service bulletin

M73-13
FAA-DER Approved

SUBJECT: Reaming and Bushing Rocker Shaft Bosses

MODELS AFFECTED: A65, A75, C75, C85, C90 O-200, O-300 and GO- 300.

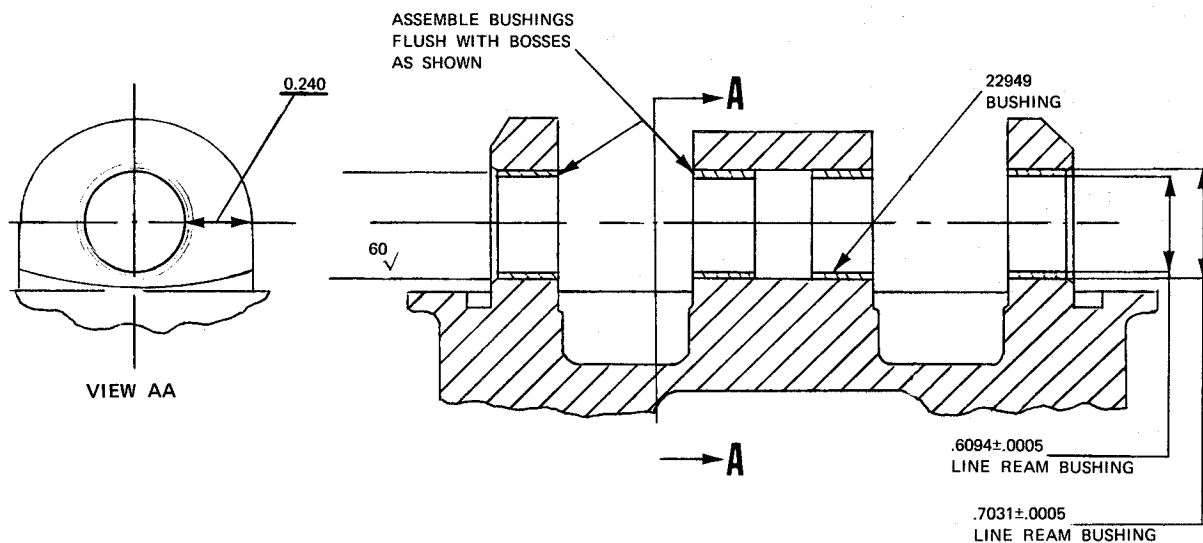
The following diagram is incorporated in our overhaul manual covering the subject engine models.

This method of repairing worn rocker shaft bosses on subject engine cylinder assemblies, is possible and recommended providing there is adequate stock in the wall at the center boss.

The following must be taken into consideration before proceeding with such repairs:

1. The minimum boss wall thickness measured at the edge of the center boss prior to any reaming and bushing must be .240 inch to be acceptable.
2. If the thickness of the center boss falls within this dimension, the bosses may be reamed. The center boss wall thickness must again be measured after reaming. If it is below .18 inch in any area, the cylinder must not be bushed and should be retired from service.
3. We cannot overstress the importance of producing a smooth finish on the inside diameter of the cylinder bosses when reaming prior to installation of the bushings. Too rough a surface bore finish can contribute to boss breakage. The bore surface roughness should not exceed 60 RMS.
